Applicant: Cong Thanh DINH
Application Serial No.: 10/764,105
Filing Date: January 23, 2004
Docket No.: 577-614
Page 8

Amendment to the Drawings:

Title: ELECTRICAL TERMINATION COMPONENT BRACKET

Fig. 3.

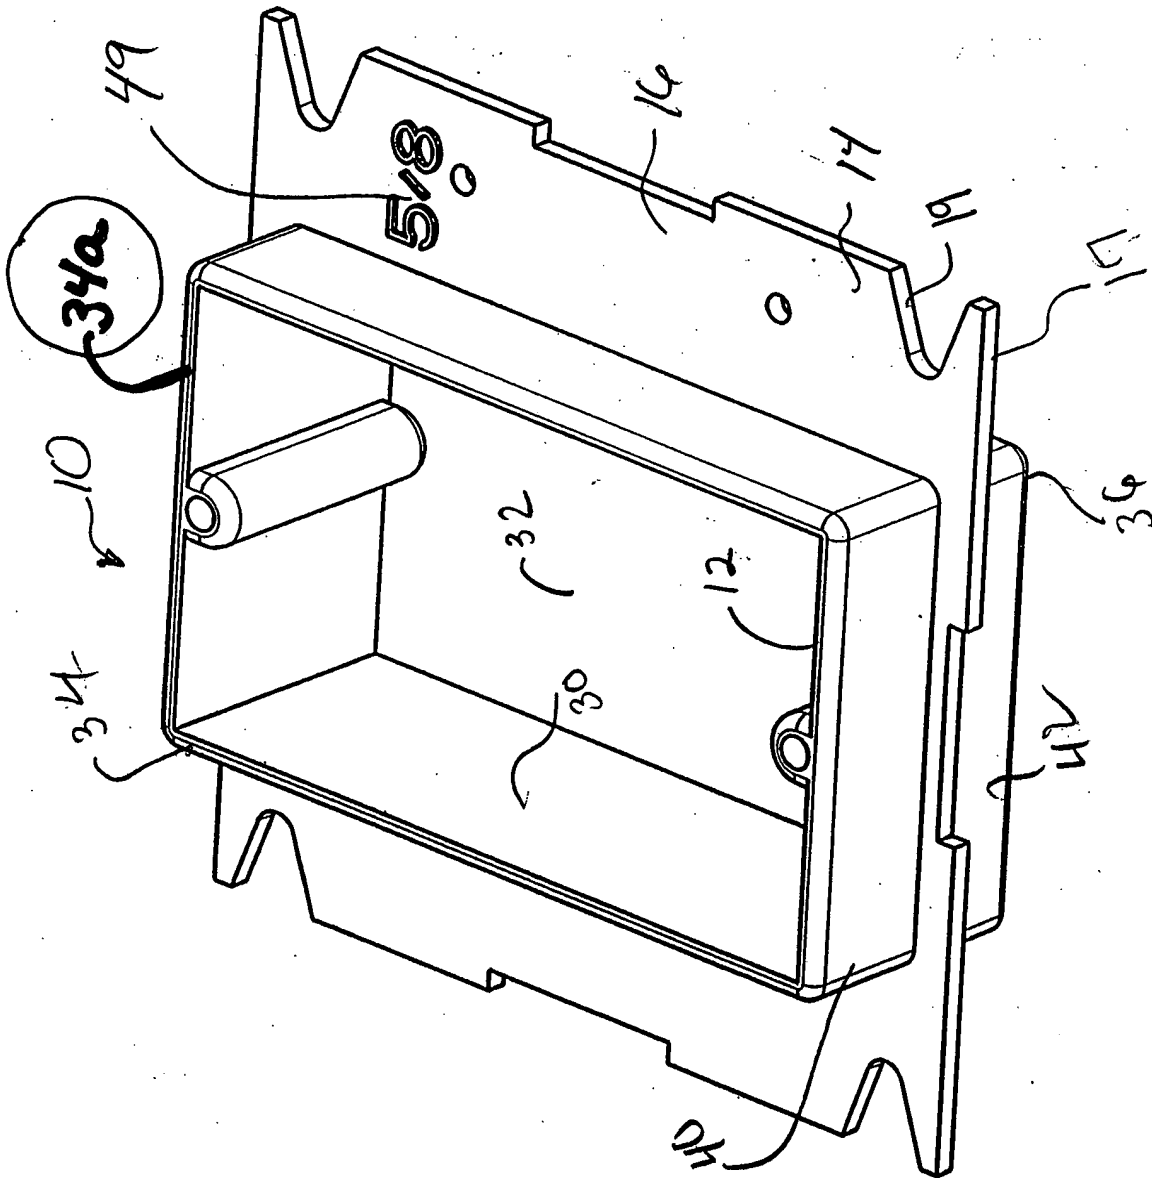
The attached sheet of drawings includes changes to Figure 3 and Figure 4. These sheets, which includes Figures 3 and 4 replaces the original sheets including Figures 3 and 4. In Figure 3, previously omitted element 34a has been added. In Figure 4, previously omitted element 36a has been added.

Element 34a added

FIG. 4

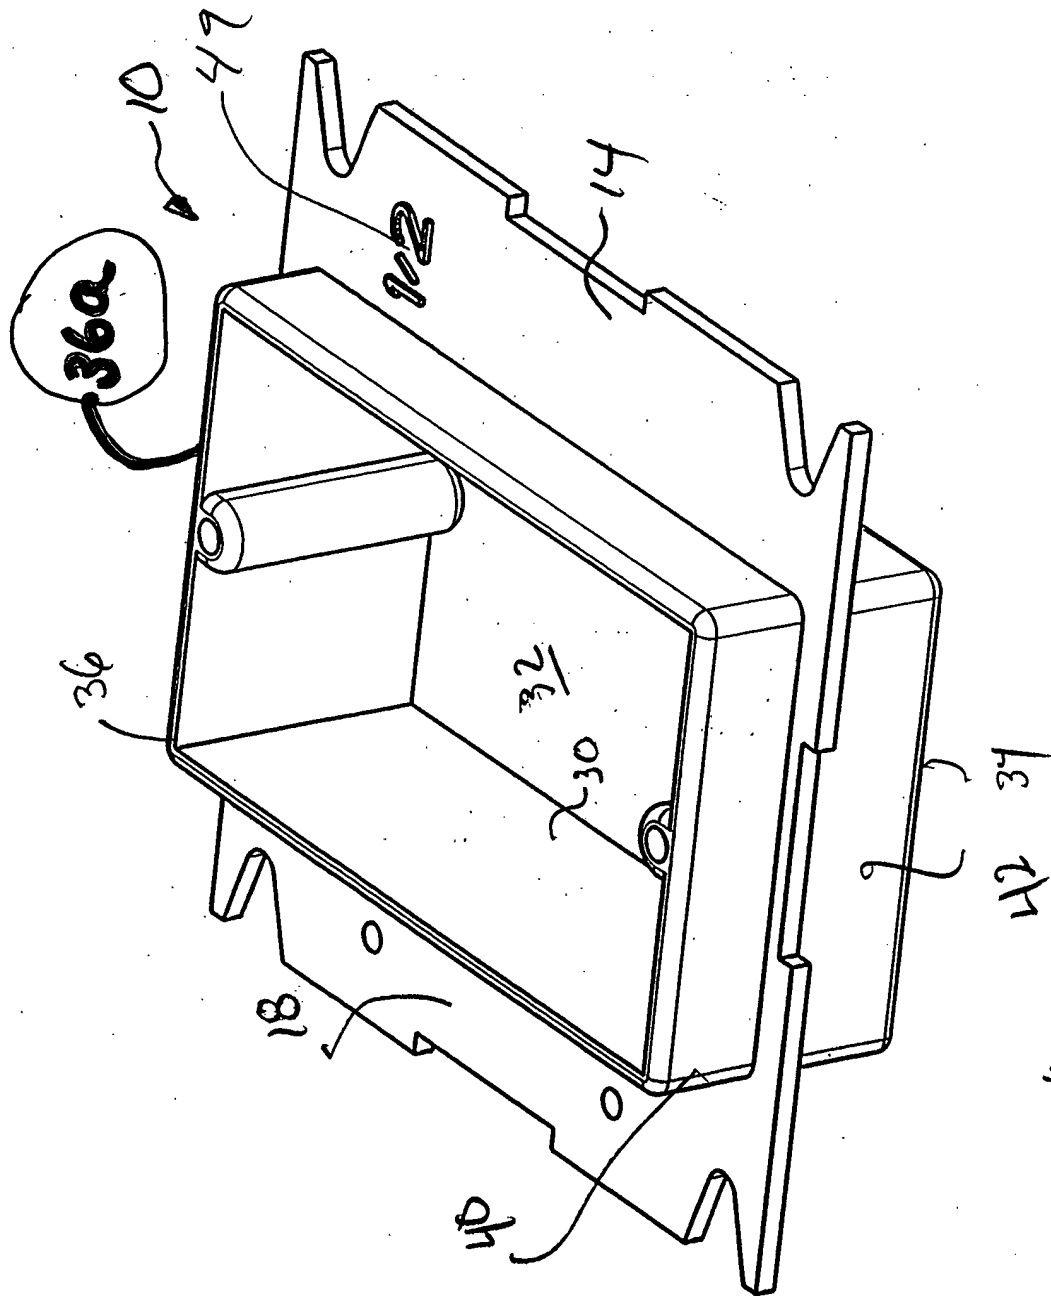
Element 36a added
